m n f m Xp i Xo e
p f m
a k Km Jo 06J o J2017J012V

A.	General Modeling Comments	2
B.	Initial CAMx Modeling	9
C.	Modeled Emission Rates:	22
D.	Direct modeling versus RRF approach	22
E.	Use of average RRFs	22
F.	Lack of 222 Days of IMPROVE Monitor Data	22
G.	CALPUFF	22
H.	CALPUFF Distance limitations	22
I.	CALPUFF Margin of error	22
J.	Inclusion of Modeled Nitrogen Dioxide 2NO2	22
K.	Model Performance	22
	1. <i>Model Performance Evaluation</i>	22
	2. <i>Nitrate Over-Predictions</i>	22
	3. <i>Sulfate Under-Predictions</i>	28
	4. <i>Underestimation of Visibility Benefits</i>	22
L.	EPA Failed to Account for Outlier Emission Rates Consistently and Modeled Nelson Unit 2 with Incorrect NOX Emission Rates	22
M.	Subject to BART finding for Entergy Waterford, Willow Glen, Ninemile Point, and Little Gypsy	22

WCleco Comment No. 4 - Review of CAMx Modeling

UNC-IE’s Total PM_{2.5} Model Performance Evaluation (EPA’s CAMx Run 1)¹⁵⁷

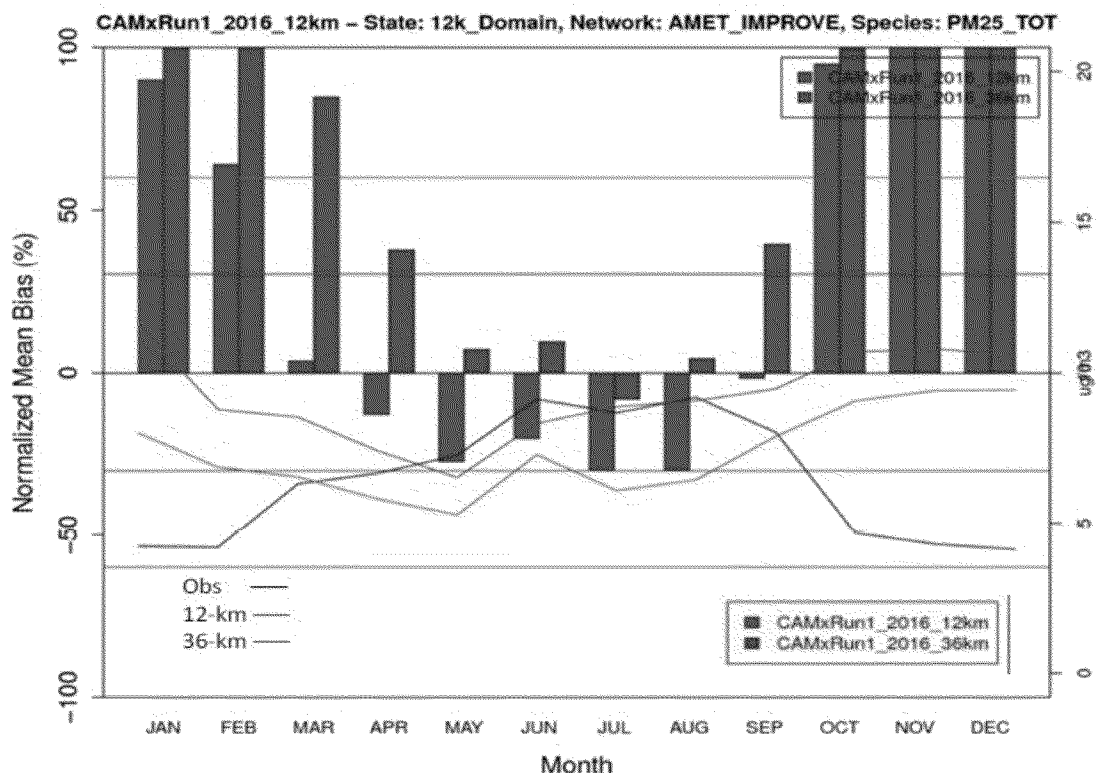
The figure above indicates that EPA’s baseline modeling performance is variable, showing a high over-prediction bias during the cooler months of the year, and a mild under-prediction bias during the warmer months. The 12 km grid simulation misses the model performance goal for total PM_{2.5} during five out of twelve months of the year (October through February), with normalized mean bias values exceeding 60%. The normalized mean bias values in November and December are notably 100% or higher.¹⁵⁸

Despite EPA and UNC-IE’s conclusion that the modeling meets EPA’s performance guidelines, this MPE indicates a relatively poor model performance. The severe over-prediction bias throughout the colder months of the year indicates that direct-modeled results have a significant likelihood for being overstated, and it is inappropriate for EPA to rely on the absolute maximum direct-modeled impacts in making its BART determinations.

For example, the maximum Cleco Brame facility impacts were predicted to occur at Caney Creek during the months that the MPE shows had particularly poor model performance, on January 5, 2002. Yet, EPA unaccountably based its conclusions about the Brame facility on this absolute maximum value without giving proper consideration to the possibility that the predicted Brame impacts could suffer from the same over-prediction bias that the overall concentrations exhibit.

As discussed in the CAMx Modeling TSD, we also compared the results of this BART modeling with the 2006/2007 evaluation of the CENRAP modeling¹⁷³ used by all CENRAP states, including Louisiana, to project future visibility conditions and identify contributions to visibility impairment from different sources types and regions. There we note that since the Class I area sets for CENRAP and the BART Screening modeling from the CAMx modeling performed by Region 6 differ substantially in the sources impacting them and in source to monitor transport, the comparison is not one-to-one (See figure 3.1-1 of the CAMx Modeling TSD). The CENRAP evaluation included comparisons with IMPROVE monitoring sites in Minnesota, Iowa, Kansas and Nebraska. The BART screening modeling and evaluation does not include these northern IMPROVE sites, but includes numerous western sites in New Mexico and Colorado. In addition, the emissions from the tagged BART-eligible sources have been enhanced with more emissions for the purposes of the BART impact analysis in the BART Screening modeling, and the model and chemical mechanism have been updated between evaluations. Because of these differences, the model performance in each evaluation is influenced by different factors related to how well the model and model inputs capture the emissions, transport, chemistry and meteorological conditions that impact each set of IMPROVE sites. In addition, the relative importance of nitrate and sulfate performance at different times of the year may differ between the two, as the CENRAP evaluation includes more northern sites that are typically more impacted by nitrate than the sites located further south. Therefore, while we can generally evaluate relative model performance between the two evaluations, it is difficult to draw conclusions on why model performance differs or is similar between the two evaluations for a particular species or time period. In general, we concluded that the model on the average is underestimating the impact of sources of SO₂ on particulate sulfate during the warmer months. Nitrate is also under-predicted in the summer months and overestimated in the winter. We also note in the TSD, that due to the overall emission levels in the base case scenario, the base case modeled impacts for sources may be underestimated due to the higher overall emissions of SO₂ and NO_x in the base case model scenario and more competition for reactants that lead to formation of visibility impairing particulate than would be seen in a cleaner ambient conditions.

Understanding the model performance, and recognizing that model performance is generally consistent with previous regional haze modeling analyses that were determined to be reliable for the purposes of regional haze planning, we concluded that:

We disagree with the comment that we based our conclusions about the Brame facility solely on the absolute maximum value of modeled impact, which the commenter notes occurred during the winter, without any consideration of the over-prediction bias for nitrate. We reviewed all the model results and evaluated not only the maximum impact, but the number of days impacted over 1.0 dv and 0.5 dv. We noted in our proposal and TSDs that with our CAMx modeling Cleco Brame had 30 days with modeled impacts exceeding 0.5 dv at Caney Creek and 10 days over 1.0 dv. We also provided model results for base case and control scenario runs for all days, including species specific extinction for review¹⁷⁵ and summarized the modeled impacts for base case and visibility benefits of controls for the maximum impacted days, the average across the top ten impacted days, and the annual average impacts (excluding days impacted less than 0.1 dv). The chart below summarizes the species specific contributions for the top ten most impacted baseline days (all ten days have impacts greater than 1 dv) for Cleco Brame Energy Center at Caney Creek. On seven of these ten days, visibility impairment due to sulfate is greater than 90% of the total visibility impact. These seven days occur during the warmer months, including days in April through early October, when model performance indicates that these modeled visibility impacts are likely under-predicted. Considering all the available modeling data, we concluded that based on modeling of base line emissions, the source is anticipated to cause or contribute to visibility impairment and is subject to BART. This supports the subject to BART determination made by LDEQ based on CALPUFF modeling that also showed visibility impacts above the 0.5 dv threshold.

() Nitrate Over-Predictions

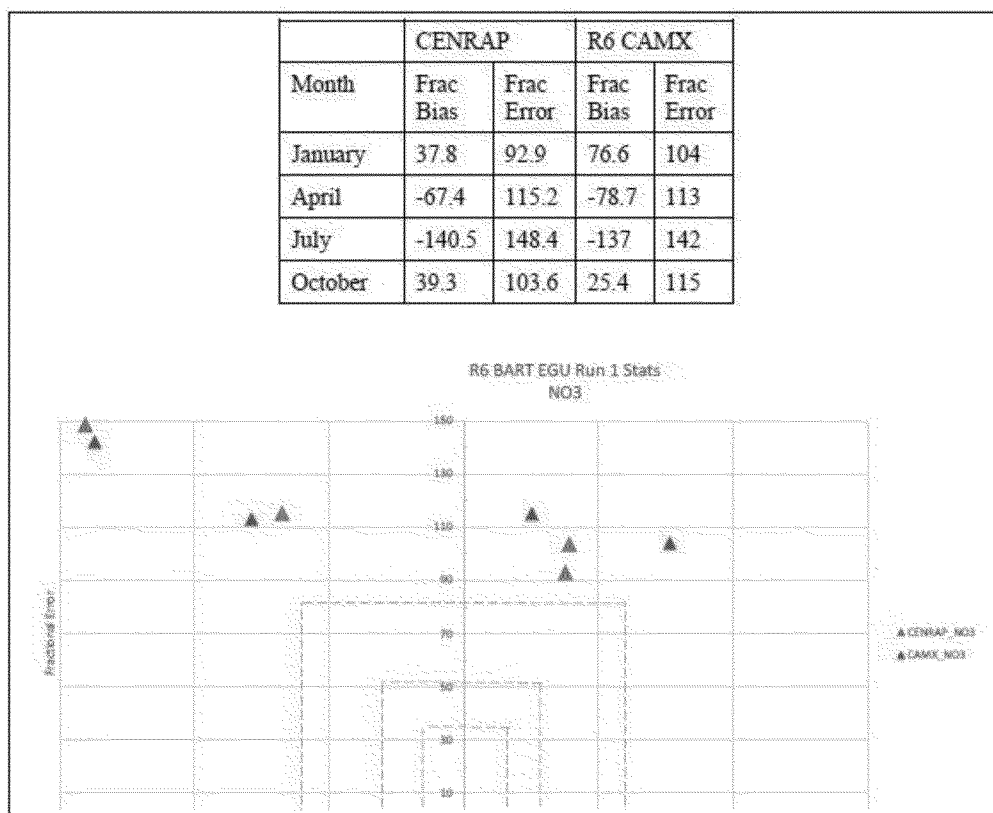
EPA makes the argument that nitrate concentrations are significantly over-predicted compared to observed values due to the fact that the BART sources are being modeled at required maximum 24-hour emission rates. By attempting to excuse the significant nitrate over-prediction bias in this way—without offering any solution to account for the effects this bias may have on individual source predictions—EPA is implicitly arguing that modeled nitrate concentrations from individual sources are acceptable despite overall nitrate predictions being significantly higher than monitored values. However, this argument is not sufficiently supported by evidence.

For example, the absolute maximum modeled impact from Cleco's Brame Unit 2 is composed almost entirely of nitrates and occurs during the winter months which are specifically singled out as having a significant nitrate over-prediction bias. In looking at this specific example, where the overall modeled haze index is 33.04 dv as compared to the monitored value of 17.81 dv, it is difficult not to infer that the model's tendency to over-predict overall nitrate concentrations is inherent to the model and may influence predictions of nitrates from individual sources as well.

o We disagree with the commenters characterization of our discussion on nitrate model performance. We do not find that nitrate concentrations are over-predicted compared to observed values solely due to the fact that the BART sources are being modeled at required maximum 24-hour emission rates. As discussed in detail in the previous response to comment and in the CAMx Modeling TSD, we found that the difference in model performance between our previous modeling (EPA R6 Texas RH study) and the current BART Screening modeling was explained by considering the difference in emissions used in the two modeling analyses. The difference in the degree of over-prediction of nitrate during the cooler months between these two analyses was explained by the use of 24-hr maximum emissions. We acknowledge in the CAMx Modeling TSD, that the CENRAP modeling as well as the additional EPA modeling runs show a tendency for over-prediction of total overall nitrate during the cooler months.

The EPA firmly believes that the peer reviewed science clearly demonstrates that photochemical grid models can adequately assess single-source impacts.^{180,181} As we discuss in response to comments above, our guidance on assessing impacts from single sources provides clarification on when “Absolute” or “direct” and “Relative” modeling approaches are appropriate when using photochemical grid models.^{182,183} The use of a relative modeling approach, using RRFs, is not appropriate for estimating maximum potential impacts due to emissions from a single source. The use of an RRF approach and observed data could result in unrealistic estimates of absolute maximum impacts from an individual source due to a number of other factors in the model not related to the specific source that affect overall model performance and any bias in overall model predictions, such as uncertainties in the overall NO_x emission inventory. We note that NO_x emissions are fairly evenly distributed across non-EGU point, EGU point, non-road mobile, on-road mobile and area sources in the 2002 emission inventory. Since the emissions and characteristics of the specific source of interest are well known, the modeled impacts will be appropriately estimated. Model performance for chemical transport models in the context of single source impact assessments for well characterized sources is intended to provide confidence in the chemical environment of the source and does not provide specific information about the amount or directionality of possible error in modeled source impacts.¹⁸⁴ In the case of the BART screening modeling, the use of maximum emissions for a number of modeled sources further complicates attempts to draw conclusions on the degree of over or under prediction of nitrates from a comparison of overall modeled concentrations to observed values at specific Class I areas.

Figure 4-4. Sulfate Model Fractional Model Bias Comparison between CENRAP CMAQ and EPA's CAMx Run 1¹⁸⁷

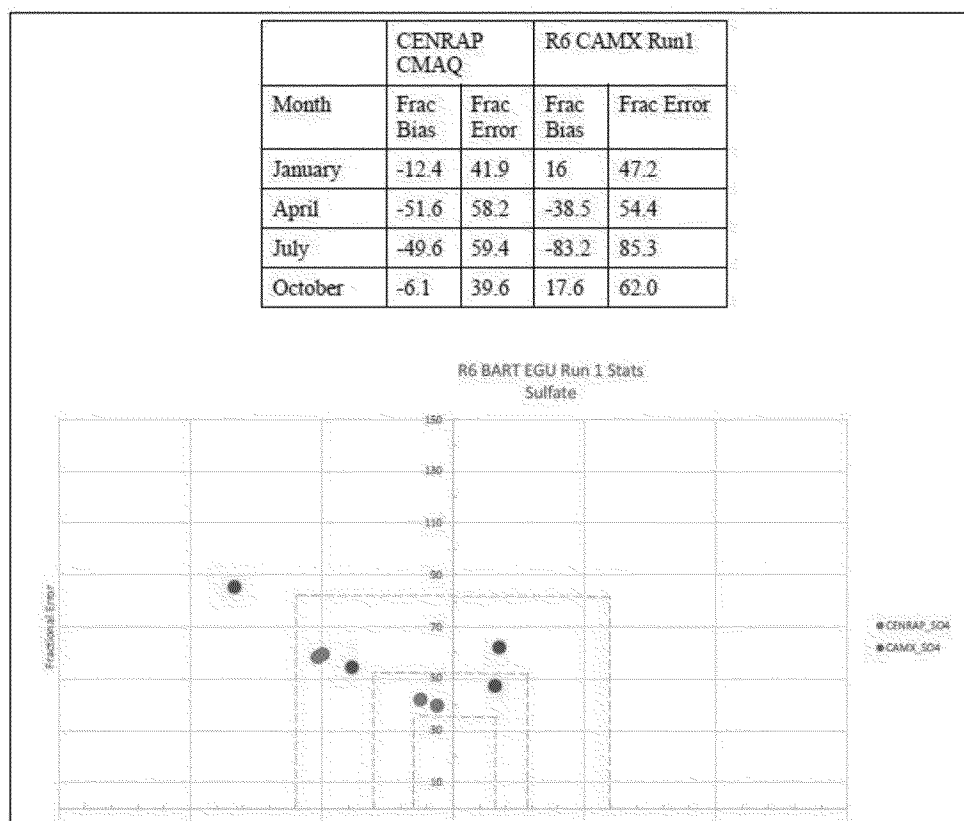
Further, EPA's statement that the impacts of BART-eligible sources are likely greater than the model predicts is baseless. Whether the actual impacts are greater or less than the model values is dependent on the date under consideration. For example, the fractional bias of sulfates in October is listed as 17.6% (see Figure 4-4) so it stands to reason that there is a chance an individual source's real impacts may be underestimated during the month of October, rather than overestimated as EPA suggests. Ultimately, based on the MPE, EPA cannot suggest a likelihood of sulfate under-prediction without simultaneously suggesting the likelihood of nitrate over-prediction.

Overall Sulfate Under-Predictions Do Not Necessarily Indicate Individual Source Under-Predictions

prediction bias is dependent on time of year, EPA should expect that the date under consideration will be a significant factor in whether actual impacts are likely greater or less than the modeled impacts. For example, an individual source's modeled sulfate concentrations are more likely underestimated by the model during January rather than overestimated as EPA suggests, because the average fractional bias of sulfates is identified as 16% in January.

o The commenters fail to present the full context of our discussion on sulfate model performance. We stated that due to the underestimate of sulfate impacts *in the summer* the impacts of the BART-eligible sources are likely underestimated and the actual impacts would be greater. Unlike NO_x emissions that are fairly evenly distributed across non-EGU point, EGU point, non-road mobile, on-road mobile and area sources, SO₂ emissions are primarily due to point sources and are well characterized. During the warmer months of the year, impacts from nitrates are not significant and visibility impairment is primarily due to sulfates. Because the model performance indicates a tendency to under-predict sulfate concentrations during these warmer months, overall SO₂ emissions are well characterized, and these BART sources are a
